From: Kelly Lark <Kelly.Lark@txdot.gov>
Sent: Wednesday, November 20, 2013 10:02 AM
To: Matthews, Patty; Parmley, Patricia
Subject: Comment for NHHIP 3rd Meeting

From: Kevin Shanley [<mailto:KShanley@swagroup.com>]
Sent: Wednesday, November 20, 2013 6:37 AM
To: HOU-PIOWebMail
Cc: 'Bob Eury'; Lonnie Hoogeboom; Robin Holzer; Kinder Baumgardner
Subject: NHHIP

From: Kelly Lark <Kelly.Lark@txdot.gov>
Sent: Tuesday, February 04, 2014 12:45 PM
To: Matthews, Patty; Parmley, Patricia
Subject: NHHIP Comment
Attachments: I-45 Proposed ROW Satellite Image.pdf; I-45 Segment 2, Alt 10 Greenways (Jonathan C.C. Day).pdf

PROPOSED TYPICAL SECTION - IH 45 (ALTERNATIVE 4)

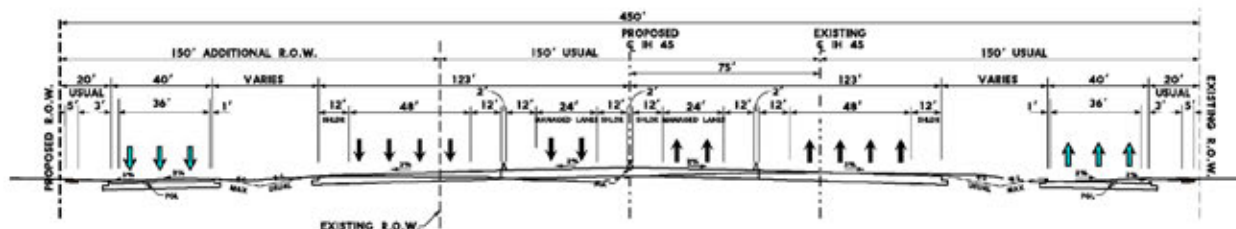
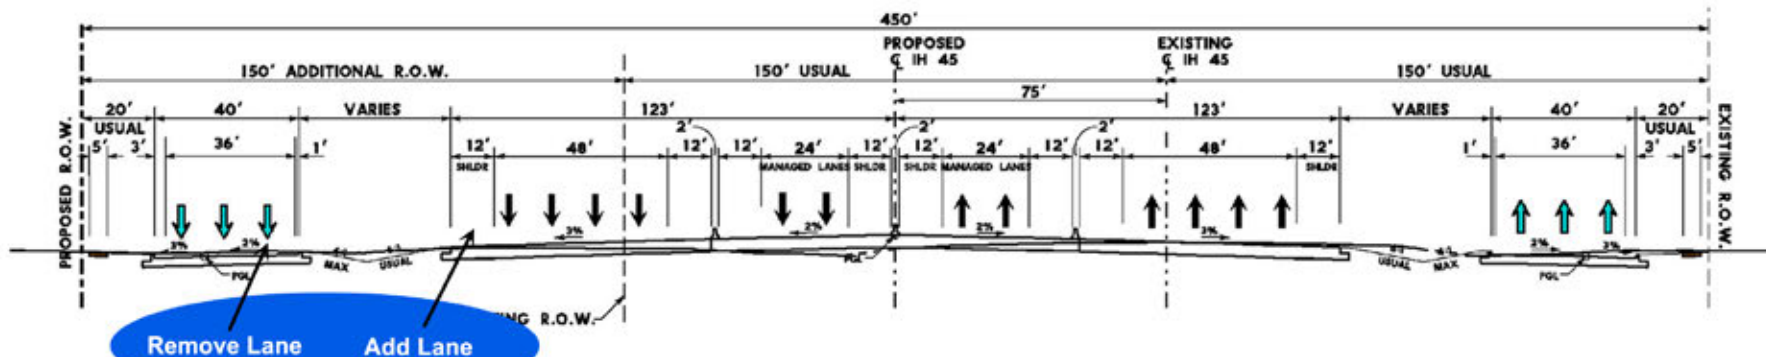
My proposal is to make five lanes from Beltway 8 to downtown. This can be easily done by removing the extra lane in the feeders and adding it to the main freeway. Some may have observed many cars in the feeder lanes, and they may have come to the conclusion that adding an extra lane would make for better flow. One of the main reasons there are so many cars in the feeder lanes is because I-45 is jam packed. My business, Reliable Edm, 6940 Fulton Street, is in the area of I-45 and North Loop 610. When I-45 is jam packed, I often take the feeder road at Tidwell and then get back on I-45.

Objective: Make a 5 lane freeway from beltway to downtown and a two-way HOV. This will move maximum traffic.

PROPOSED TYPICAL SECTION - IH 45 (ALTERNATIVE 5)

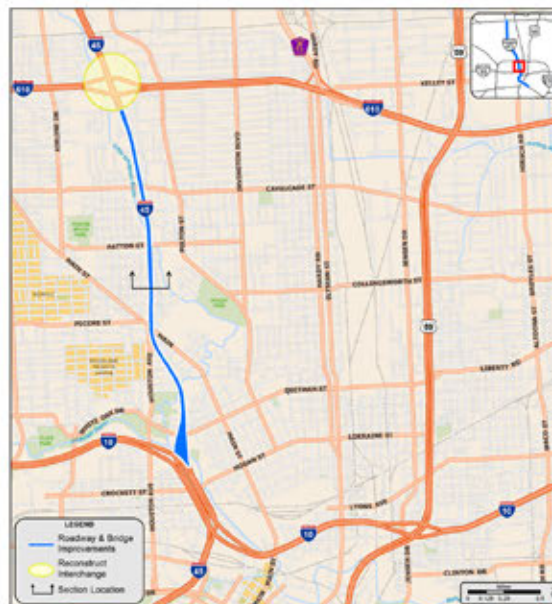
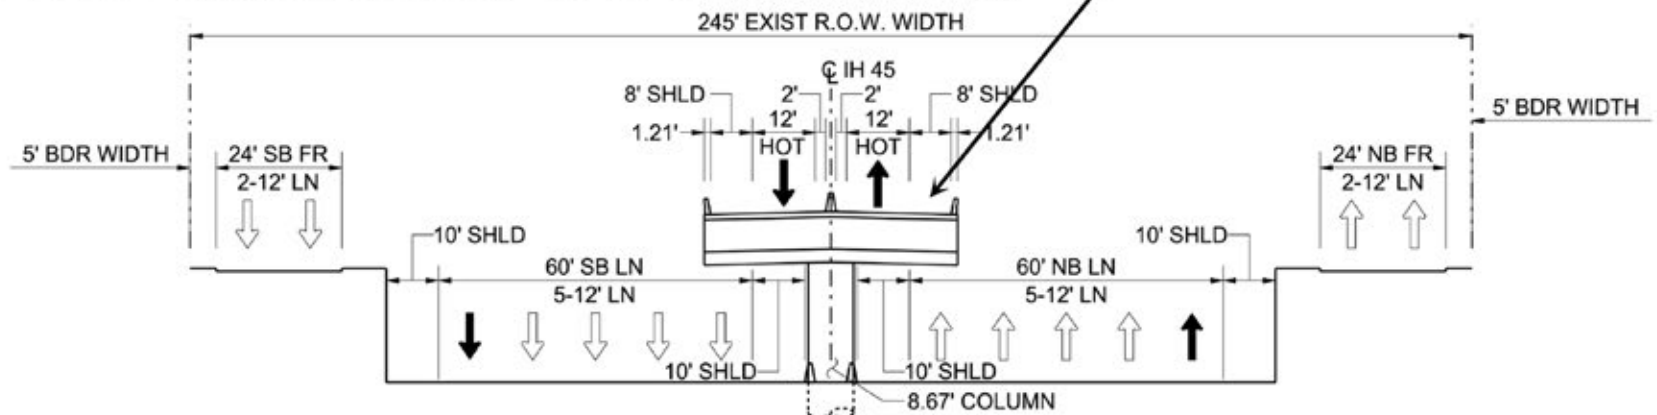
My suggestion for 610 to I-10 is to make the HOV lanes into four lanes. I do not know if the traffic justifies this, but I think for what lies for the future for Houston, it would be a benefit to make it into a four lanes.

Widen to four lanes

PROPOSED TYPICAL SECTION - IH 45 (ALTERNATIVE 4)

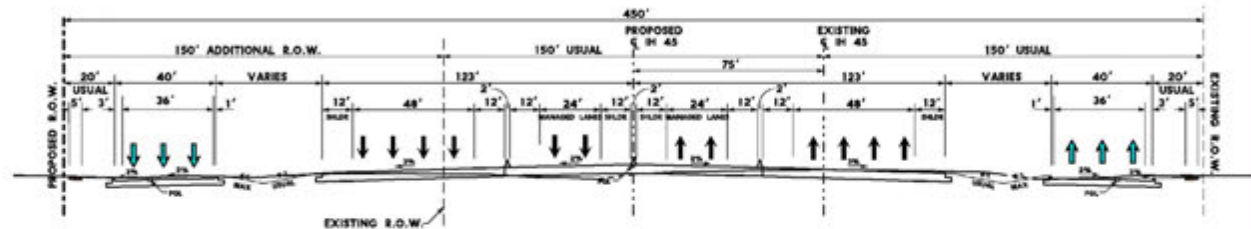
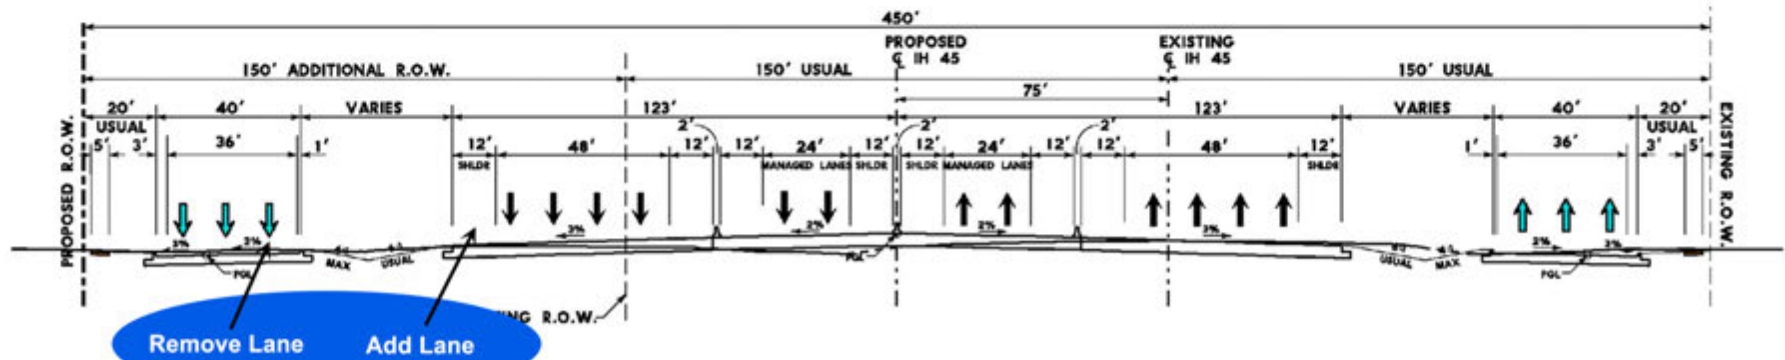
Objective: Make a 5 lane freeway from beltway to downtown and a two-way HOV. This will move maximum traffic.

PROPOSED TYPICAL SECTION - IH 45 (ALTERNATIVE 5)

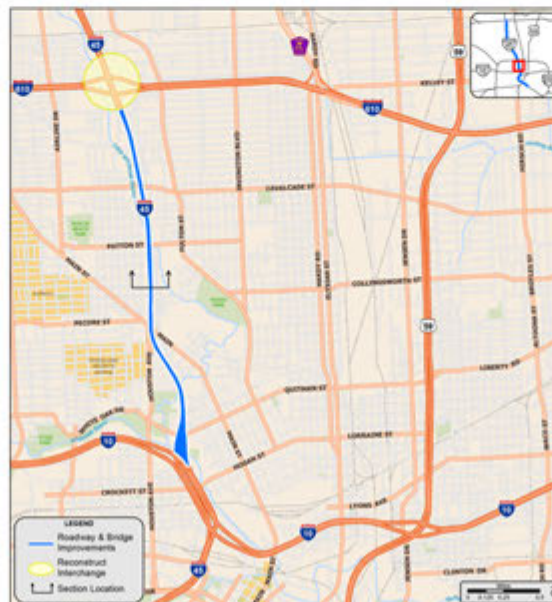
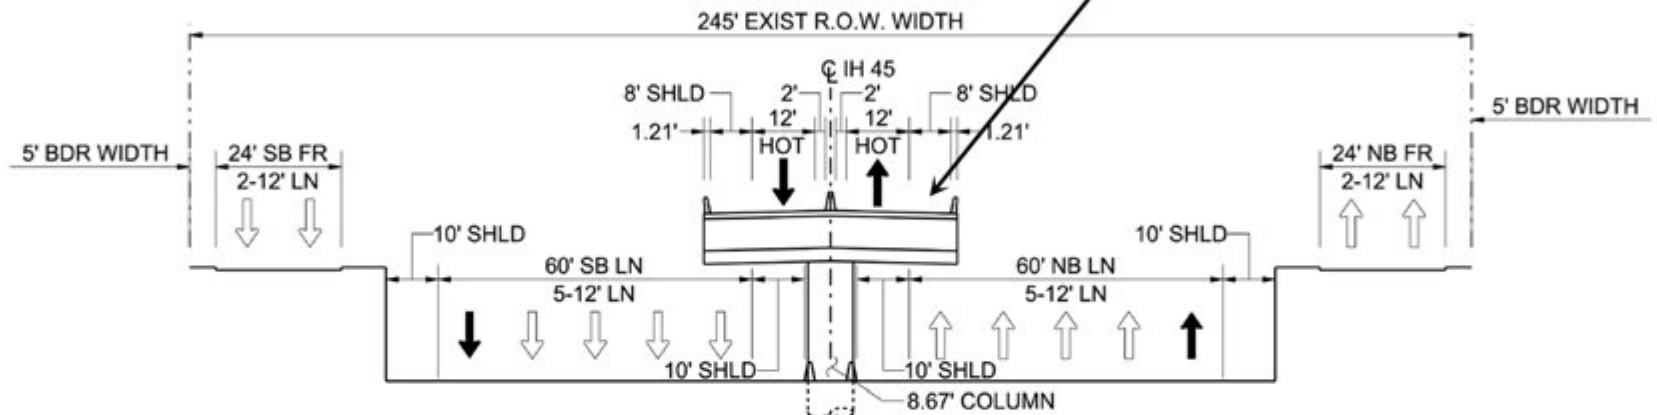
Objective: Make a 5 lane freeway from beltway to downtown and a two-way HOV. This will move maximum traffic.

Widen to four lanes

Section 2 I-45 from I-610 to I-10

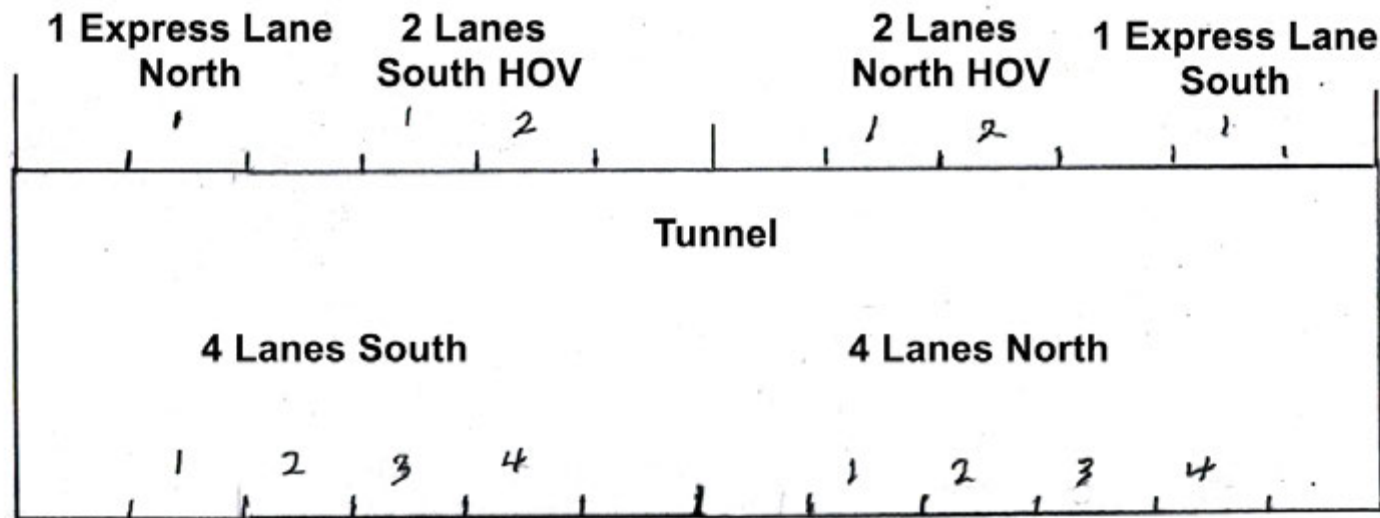
Portion promised to residents that no future land would be taken for highway expansion.
